SHENZHEN DEXIHONG USB CABLE REVIEW

Date: 15th June 2020
Revision: 1.0
Author: Tony Little
Product: Electric Skateboard
Company: Globe Brand

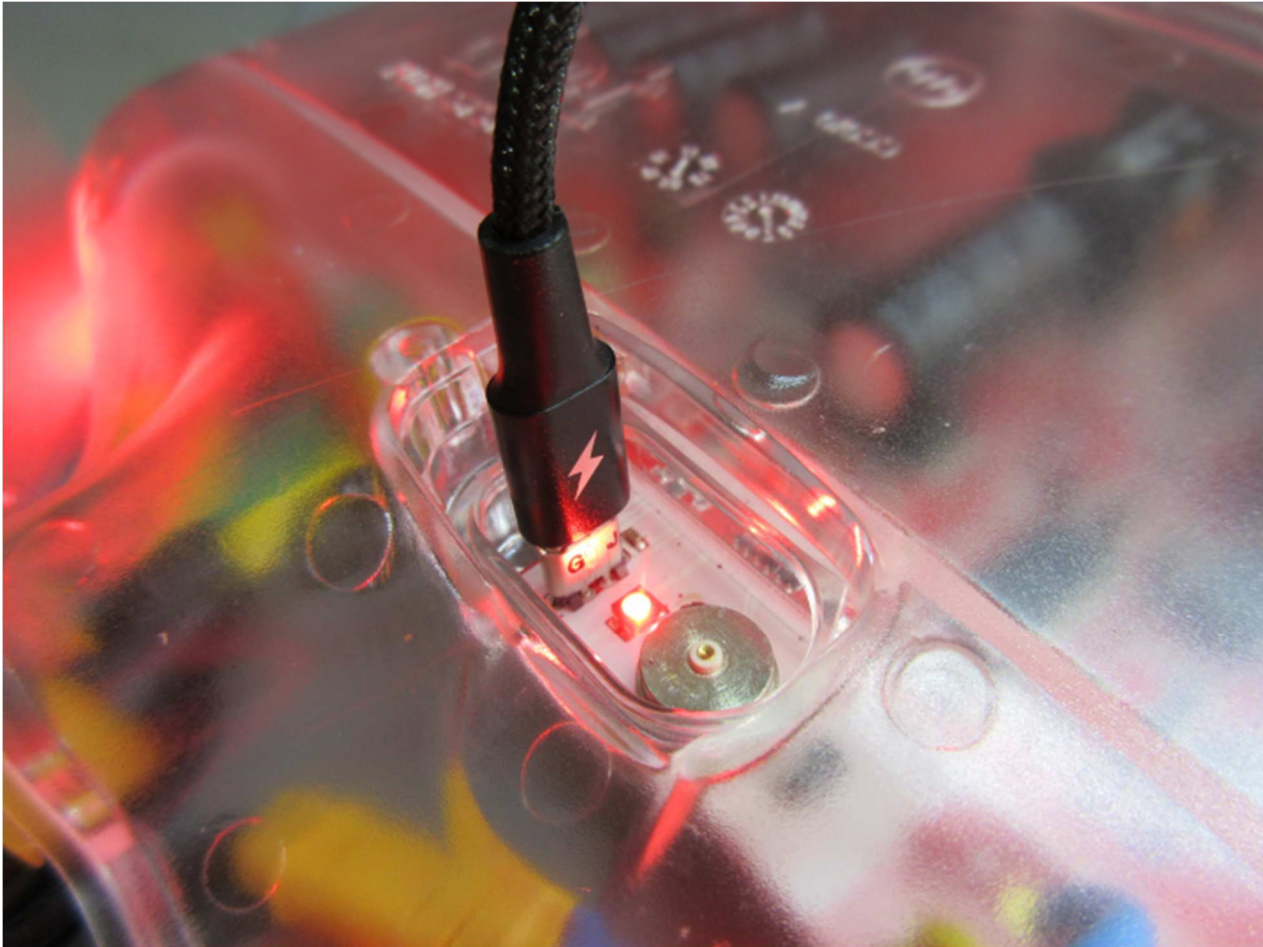
100 units (not counted) were received from Shenzhen Dexihong. One bag shown below.

The quality is quite good. Nylon braiding feels good and the TPE necks to the connectors adds good robustness.

Electrically the cable measures as a basic straight through connection, which is ideal.

The cable mechanically fits the remote without issue. Mating retention is as expected. Firmware update was run while jiggling the cable throughout. No dropout. Battery charging and end of battery charging also tested.

Cable fits and functions with the main controller without issue.
